CITY of NOVI CITY COUNCIL

**Agenda Item 1
January 7, 2019**

SUBJECT: Approval of the request of Applicant Erhard Motor Sales, Inc., and Developer Winfried Dahm for a Special Development Option (SDO) Agreement in the GE, Gateway East District. The subject property is 9.48 acres of land located at the southwest corner of Grand River Avenue and Meadowbrook Road, in Section 23. The applicant and Developer are proposing a 58,663 square foot car sales facility for Jaguar Land Rover.

JSP 17-65: JAGUAR LANDROVER

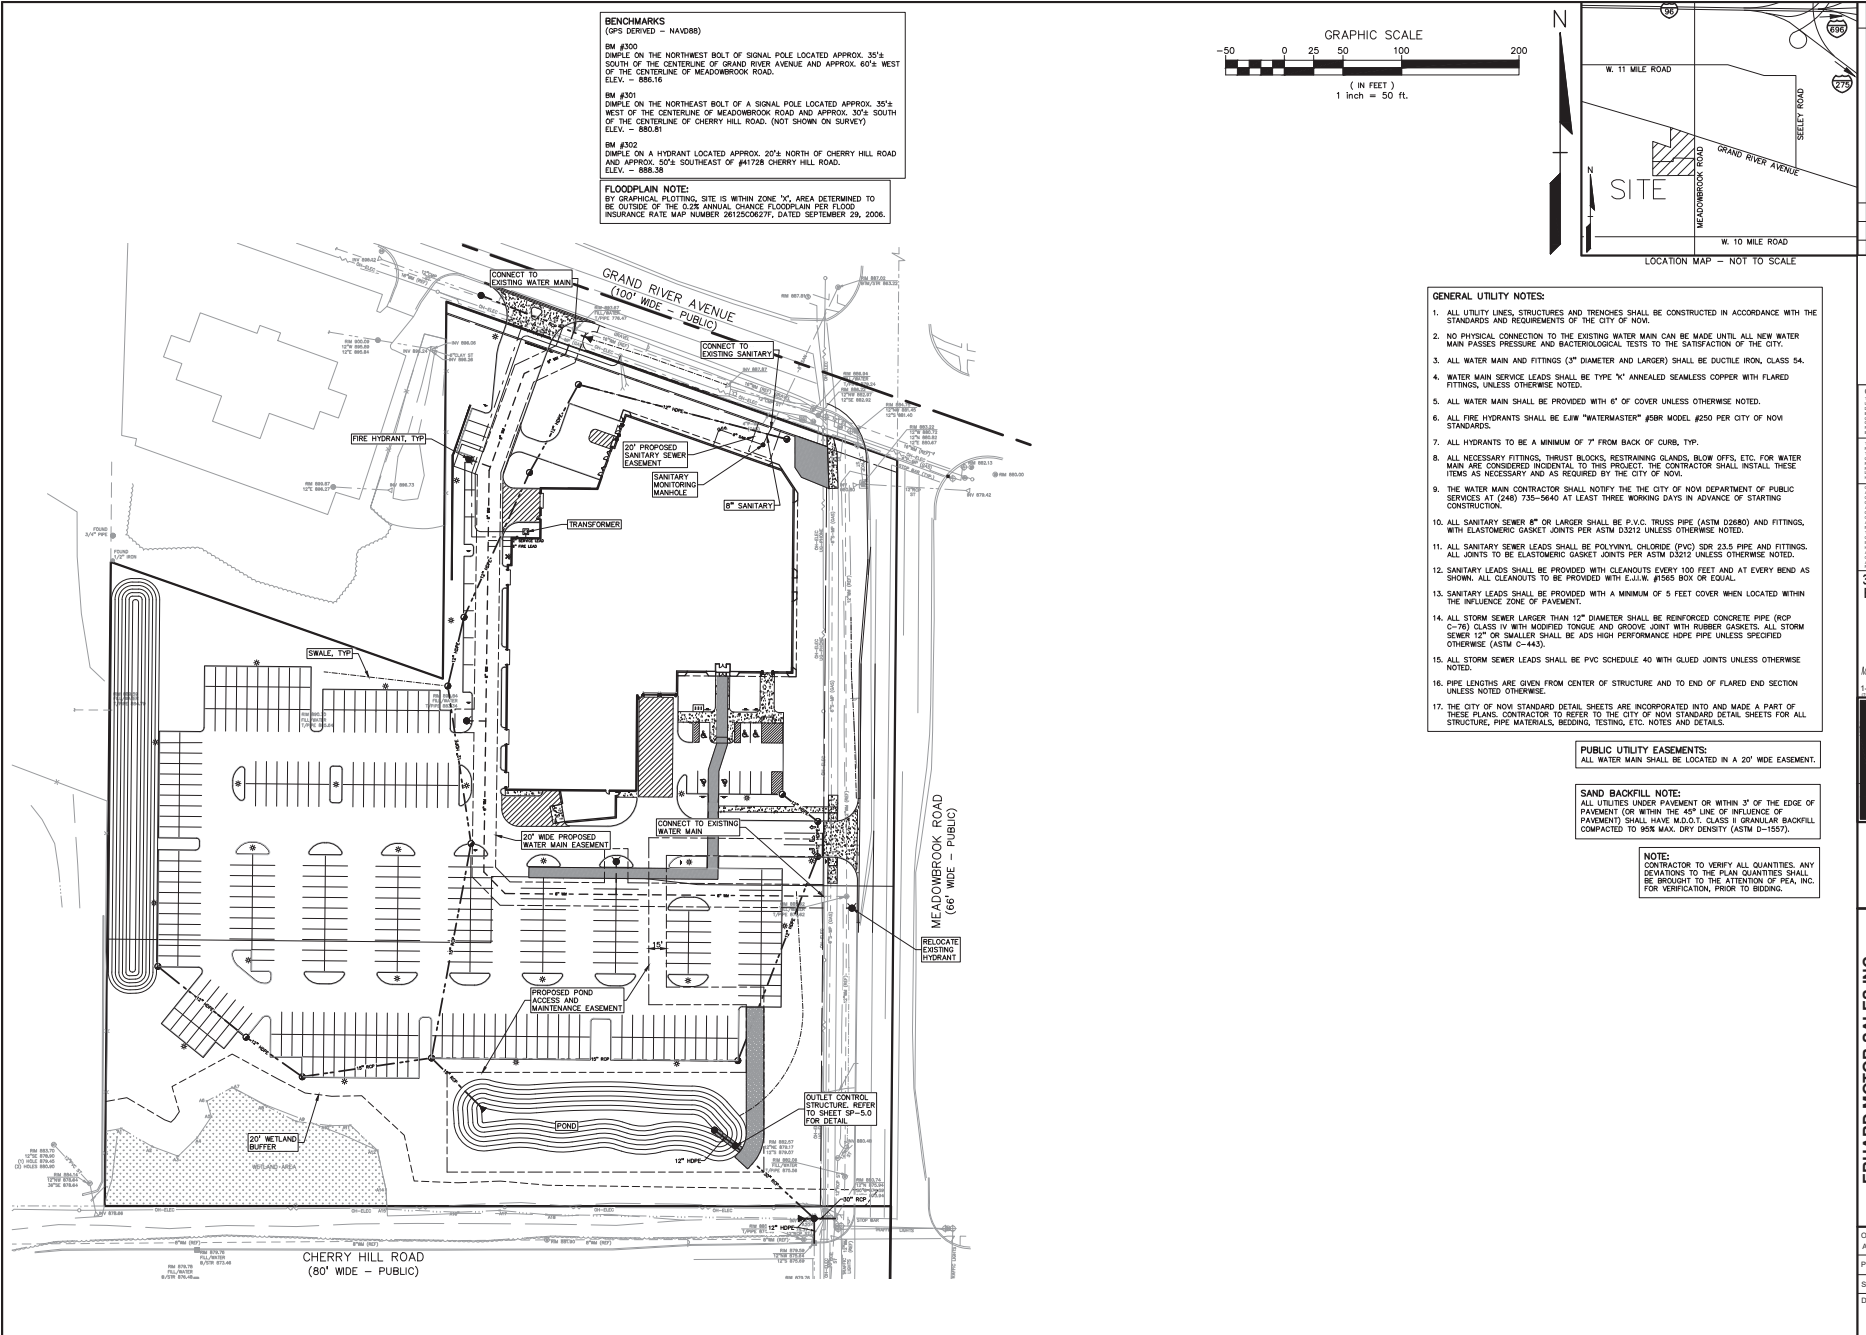
- f. The applicant is required to provide two (2) bicycle parking spaces for the service center section of the development and six (6) have been provided. A bicycle parking layout is shown on sheet SP-2.0 but a dimension for the width of the sidewalk should also be included.

Updated calculations demonstrating compliance with the Open Space requirements will be added to sheet SP-2.0.

Bike racks will be relocated to limit the number of racks at any one entrance on sheet SP-2.0.

Additional calculations will be added to SP-2.0 to demonstrate conformance with open space requirements.

Corner clearance zones will be added to SP-2.0 to the next resubmittal.

ORIGINAL ISSUE DATE: AUGUST 6, 2018
PEA JOB NO. 2017-176
SCALE:
DRAWING NUMBER:
SP-6.2

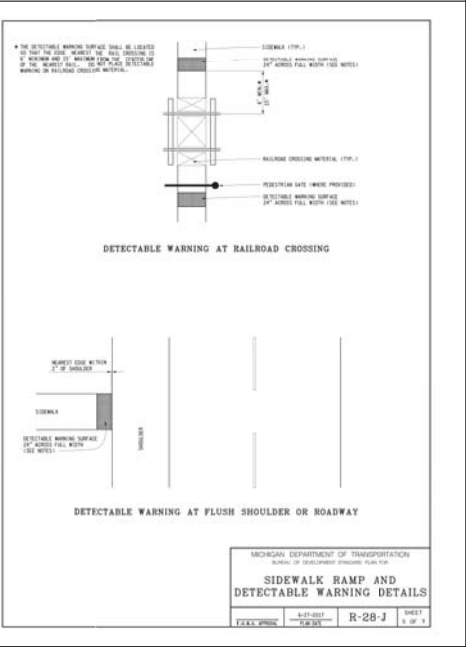
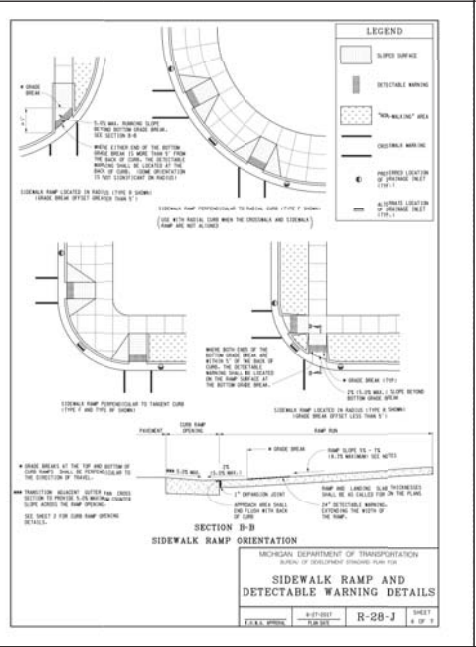
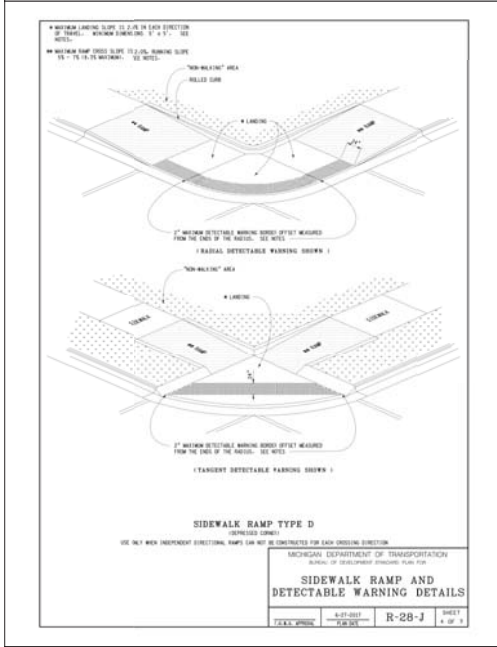
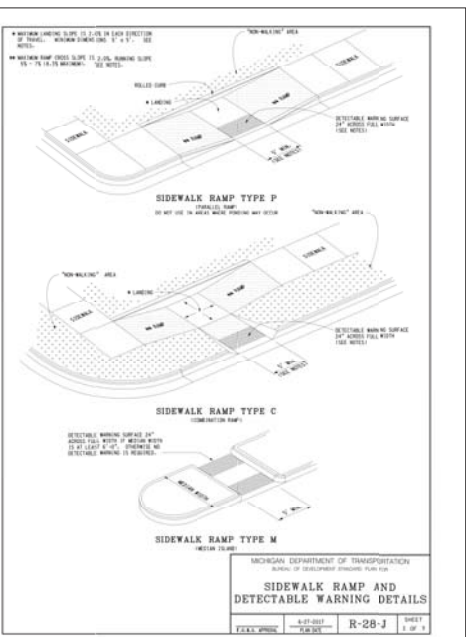
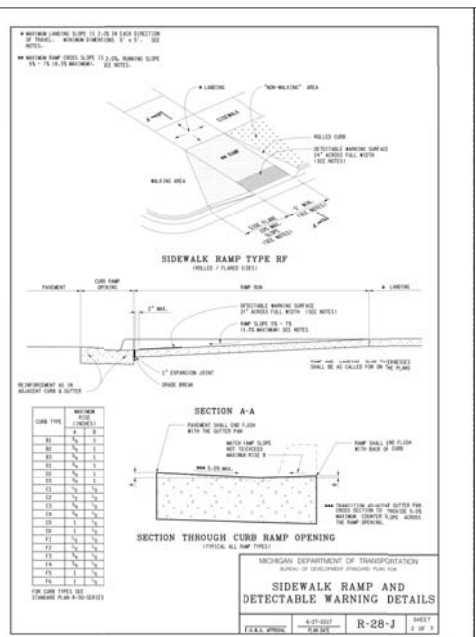
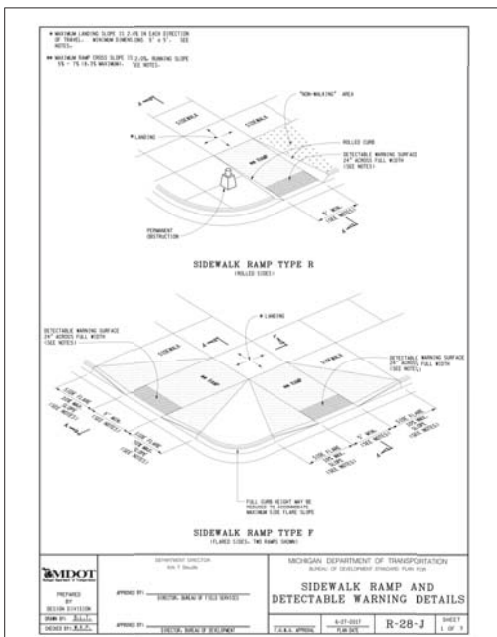
- i. It should also be noted that the note on sheet SP-3.0 indicates four inch curbs while the detail on sheet SP-6.2 indicates 6" curbs.
 - ii. The applicant should indicate that 6" curbs are required at the parking end islands as well as the four (4) 19' long parking spaces on the west side of the site.

- i. **It should also be noted that the note on sheet SP-3.0 indicates four-inch curbs while the detail on sheet SP-6.2 indicates 6" curbs.**

DRAWING NUMBER:
T-1.0

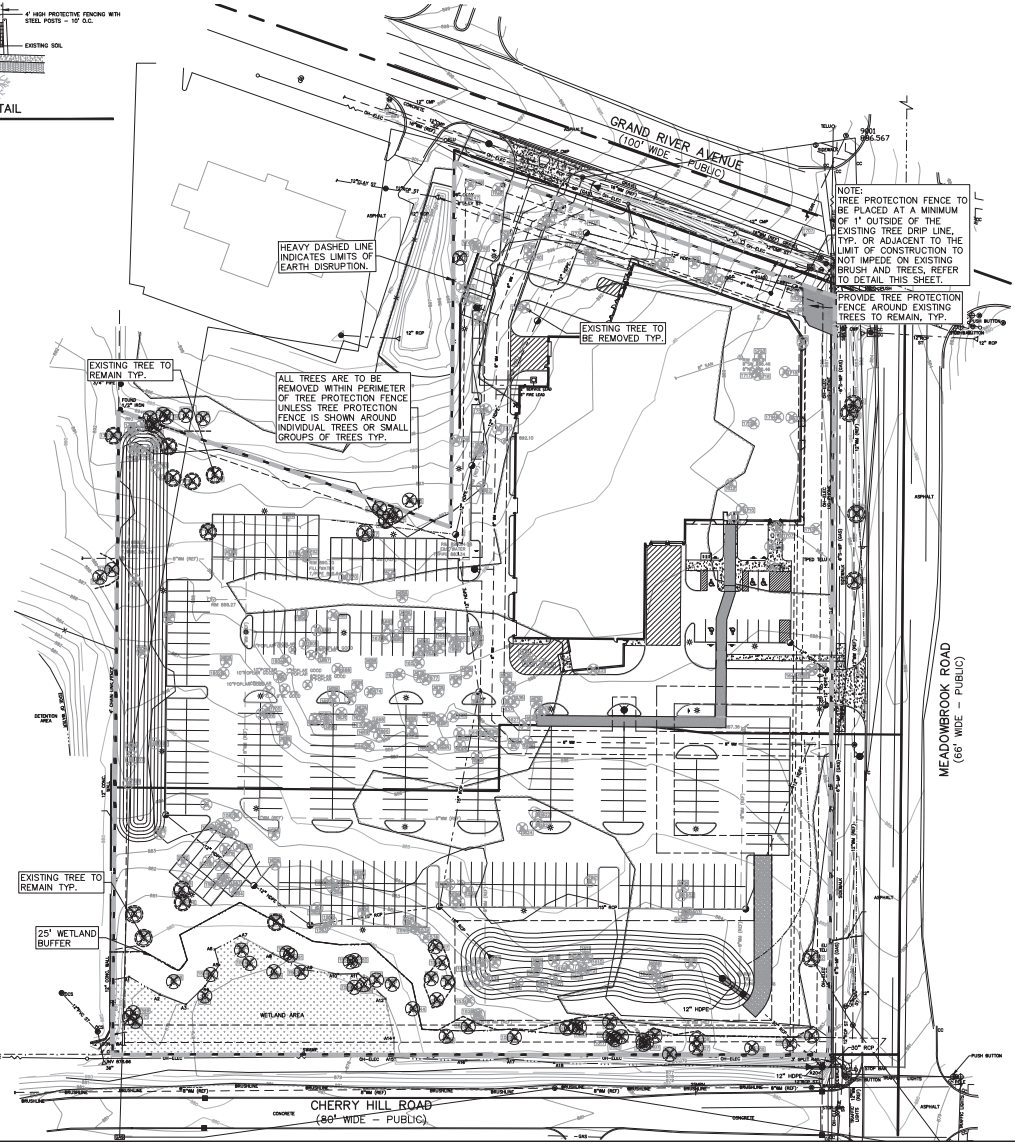
The *Tree Preservation Plan* (Sheet T-1.0) notes that **172** Woodland Replacement Tree credits are required and that a total of **172** on-site Woodland Replacement Tree credits are proposed with a mix of canopy (deciduous) trees and evergreen trees.

The Plan includes a *Tree Plant List* on Sheet T-1.0, that lists the species of the proposed Woodland Replacement Trees; however it does not currently appear to specify the quantity of each species that will be used as Woodland Replacement tree credits. The applicant should, for example, specify how many of the 28 hophornbeam listed in the list are Woodland Replacement Trees as opposed to Perimeter Parking Lot or Landscape trees, etc. All of the tree species proposed as Woodland Replacement Tree material appears to be acceptable per the City's Woodland Tree Replacement Chart, however, the applicant shall specify the thornless honeylocust (*Gleditsia triacanthos inermis*) on the Plan.

2. The Plan includes a *Tree Plant List* on Sheet T-1.0, that lists the species of the proposed Woodland Replacement Trees; however it does not currently appear to specify the quantity of each species that will be used as Woodland Replacement tree credits. The applicant should, for example, specify how many of the 28 hophornbeam listed in the list are Woodland Replacement Trees as opposed to Perimeter Parking Lot or Landscape trees, etc.

Proposed Elevations

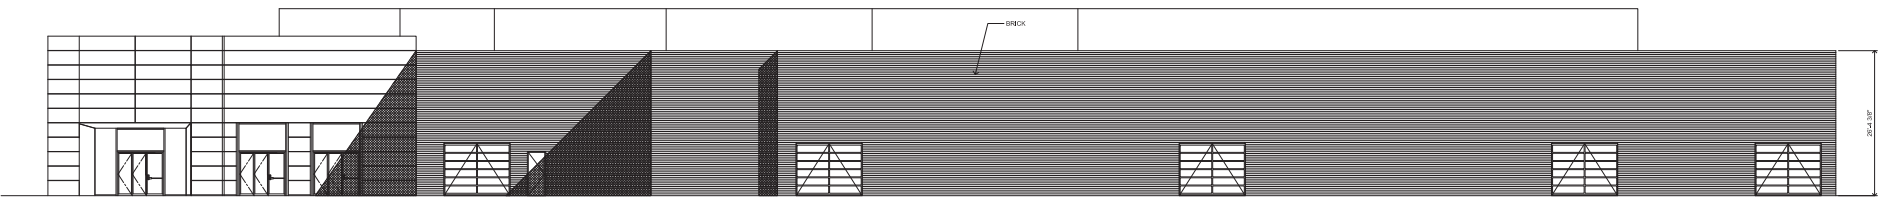
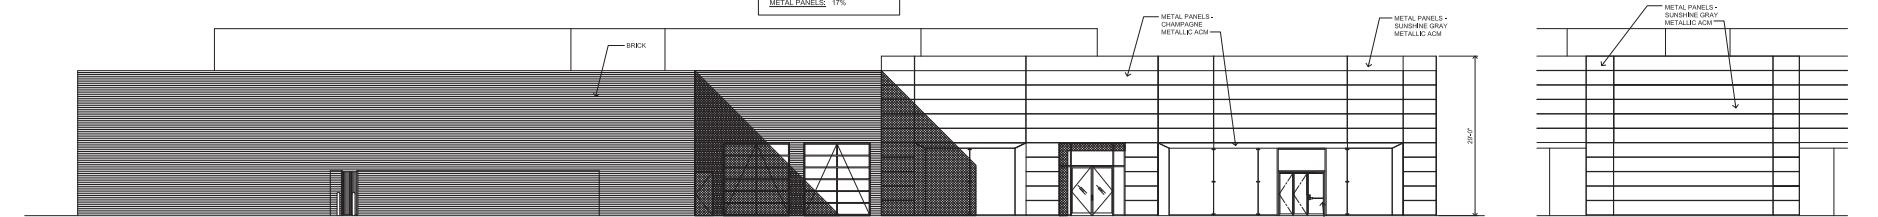
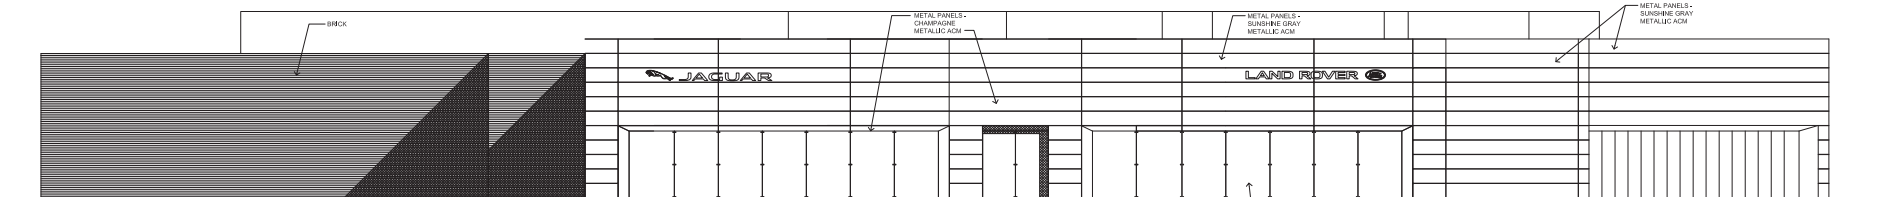
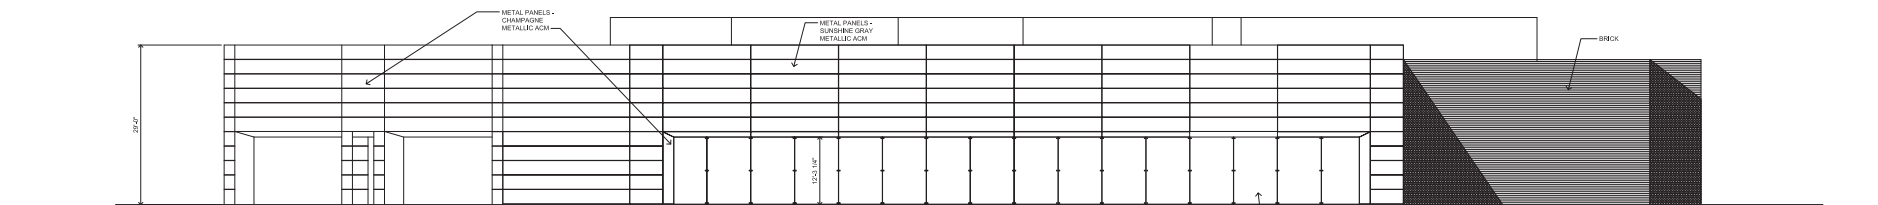
- i. Underage of brick (30 percent minimum required, 25 percent on north façade and 28 percent on east façade proposed);
 - ii. Overage of flat metal panels (50 percent maximum allowed, 58 percent on north façade and 56 percent on east façade proposed);

- iii. Overage of horizontal rib metal panels for roof top screening (0 percent allowed, 17 percent on north, 16 percent on east, 12 percent on south and 18 percent on west proposed);
